UNITED STATES PATENT AND TRADEMARK OFFICE

APPLICATION NO.	FILING DATE	FIRST NAMED INVENTOR	ATTORNEY DOCKET NO.	CONFIRMATION NO.
10/604,378	07/15/2003	Satoshi Shahana	SIC-03-019	1377
29863	7590	11/01/2005	EXAMINER	
DELAND LAW OFFICE P.O. BOX 69 KLAMATH RIVER, CA 96050-0069			CHARLES, MARCUS	
			ART UNIT	PAPER NUMBER
			3682

Office Action Summary	Application No. 10/604,378	Applicant(s) SHAHANA, SATOSHI	
	Examiner Marcus Charles	Art Unit 3682

DETAILED ACTION

FIG. 3

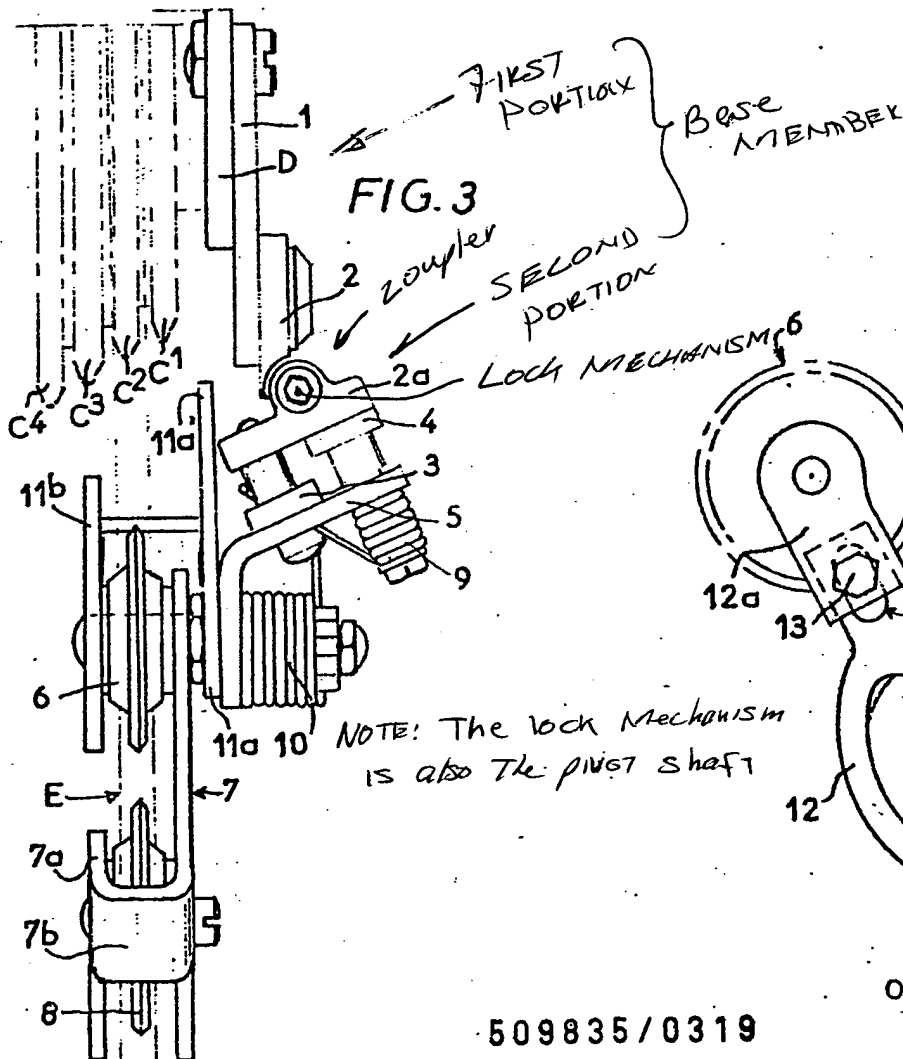
In claim 2, note the first and second portions are structured to fold via a pivot (se fig. 3).

In claims 4 and 5, note the coupler and the pivot shaft in fig. 3.

In claim 7, DE (2507213) discloses the claimed invention above, including the locking mechanism, which is also the pivot shaft, which is the shaft that is structured to in a locking and unlocking position (see attached drawing).
